RIVERS PHASE II

Final Environmental Impact Report

SCH 2005042018

April 2006

FIGURE 3-3
Vesting Tentative Subdivision Map

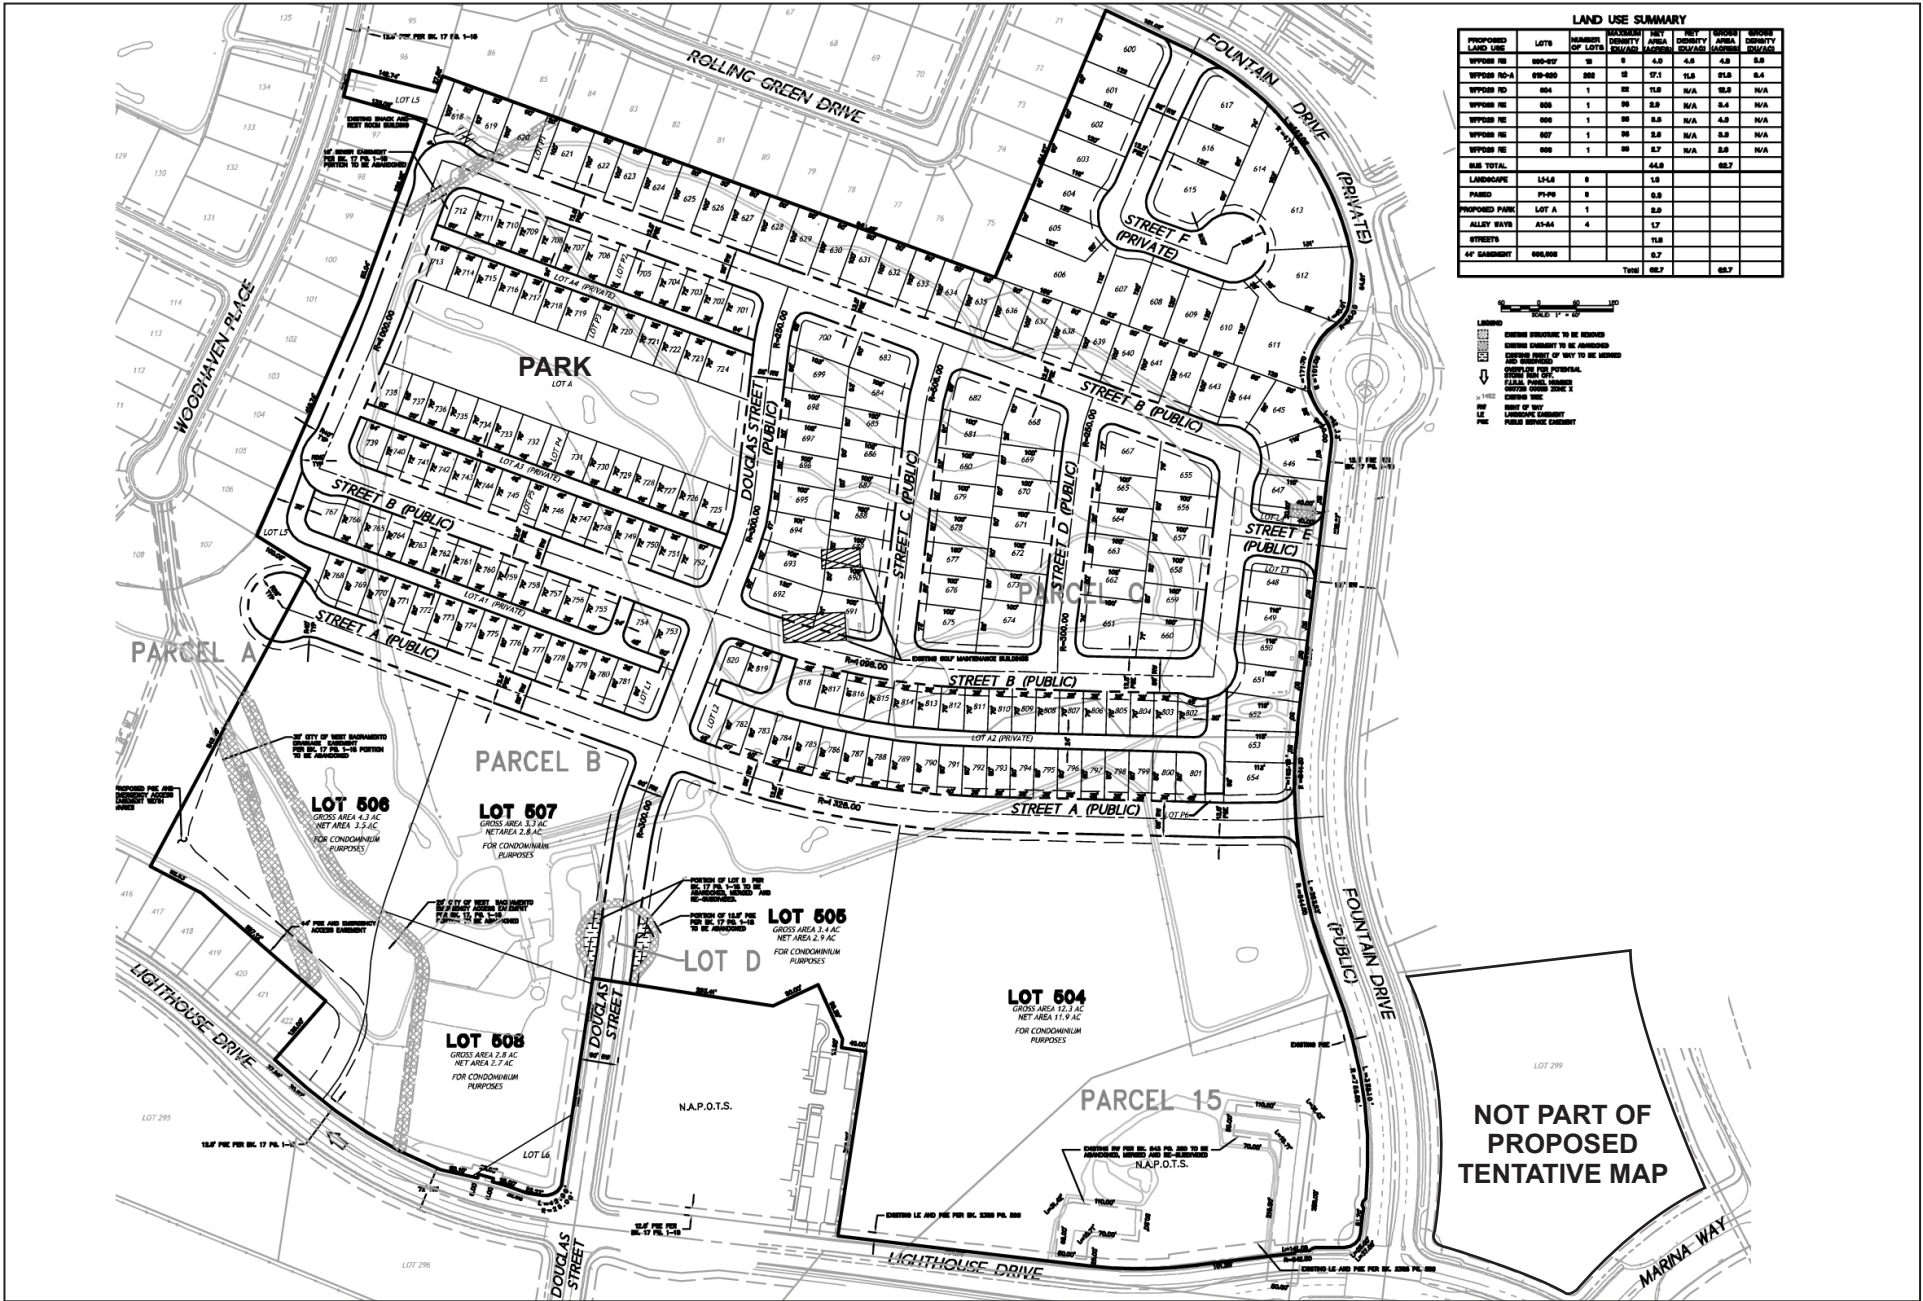
Figure 3-3, Vesting Tentative Subdivision Map, on page 3-7 of the Draft EIR is revised to note that the lots designated RD and RE single-family attached units would be developed as condominiums. This does not change the conclusions of the Draft EIR. The revised figure is included at the end of this chapter.

FIGURE 3-8B
MBK Levee Typical Cross Section

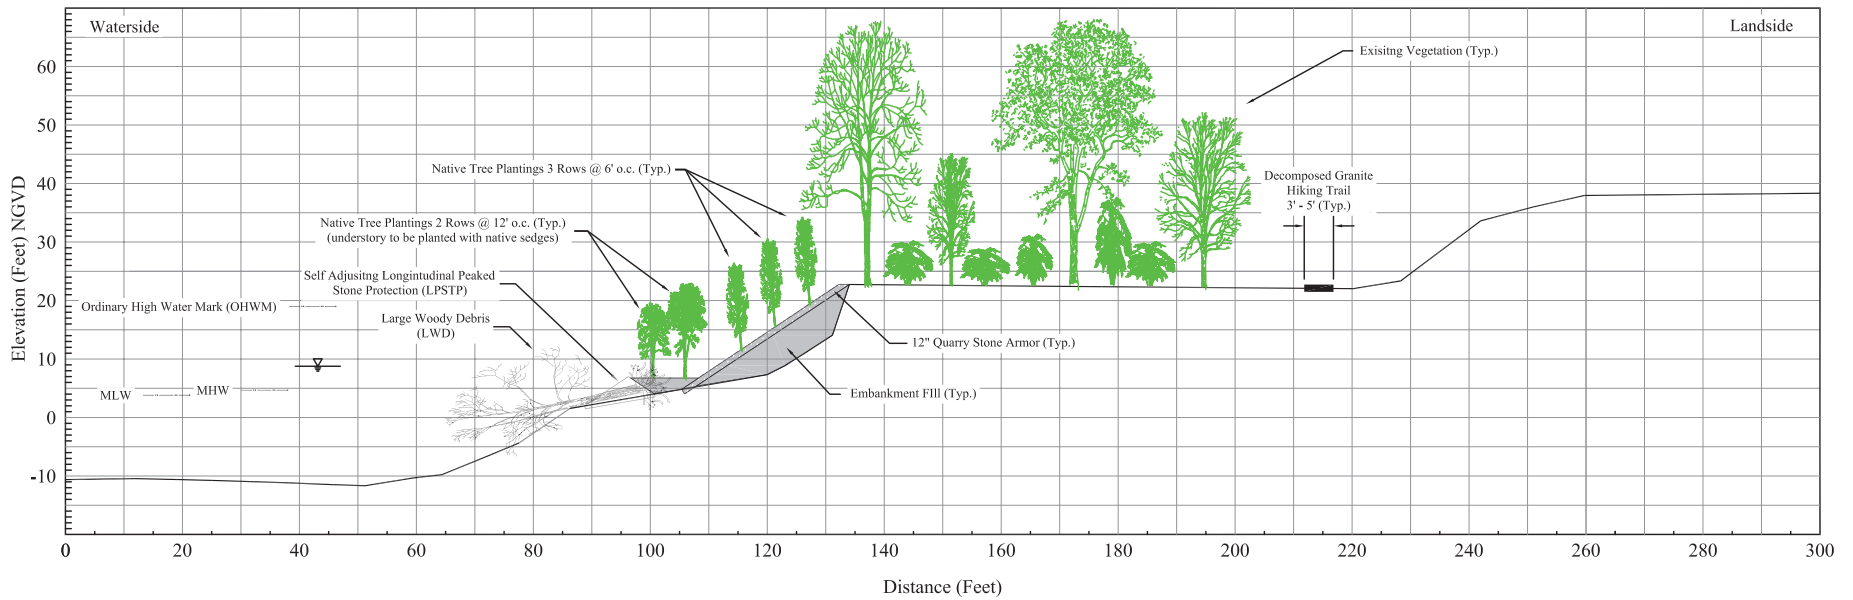
Figure 3-8, MBK Levee Typical Cross Section, on page 3-16 of the Draft EIR has been revised to include the proposed informal hiking trail and is included at the end of this chapter. In addition, the figure numbers are revised and the new figure numbers are 3-8a and 3-8b.

The proposed bank stabilization project evaluated in the Draft EIR for the Rivers Phase II EIR is not the same as the project described in the 1991 Boundary Line Agreement. The bank stabilization project is described on page 3-15 of the Draft EIR and the boundaries are shown in Figure 3-8b found in Chapter 2 of this Final EIR.

Access to and from the informal trail along the bank stabilization project is shown on Figure 3-8b in Chapter 2 of this FEIR.

Figure 3-8, MBK Levee Typical Cross Section, on page 3-16 of the Draft EIR has been revised to include the proposed informal hiking trail and is included in Chapter 2 of this Final EIR. In addition, the figure number is revised and the new figure number is 3-8b.

FIGURE 4.6-1
Existing PD-29 Designations

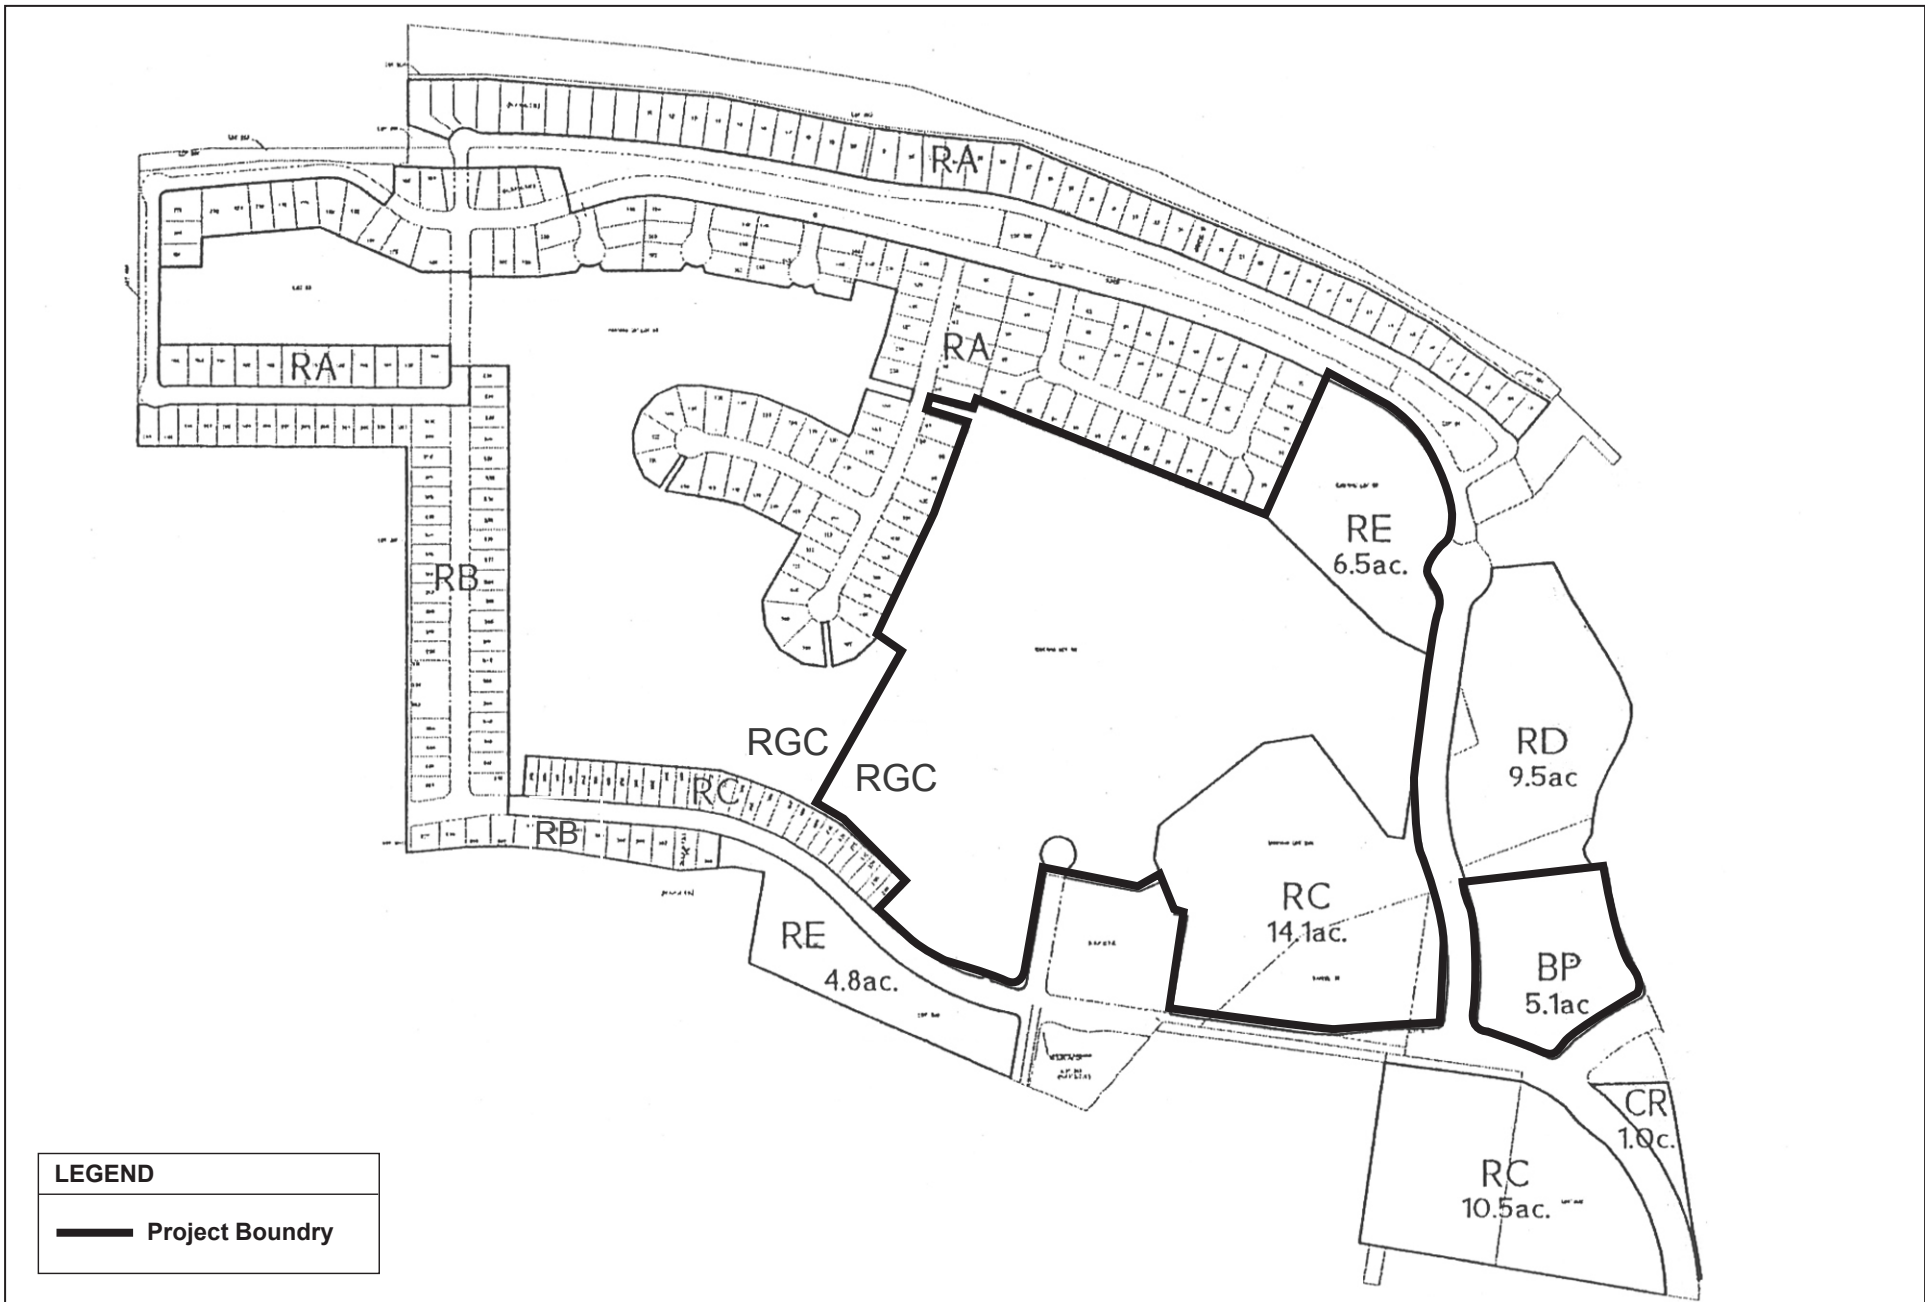
Figure 4.6-1, Existing PD-29 Designations, is revised to show the RB designation in the southeast portion of the site. Additionally, the BP/CR designation is changed to BP. The revised figure is included at the end of this chapter.
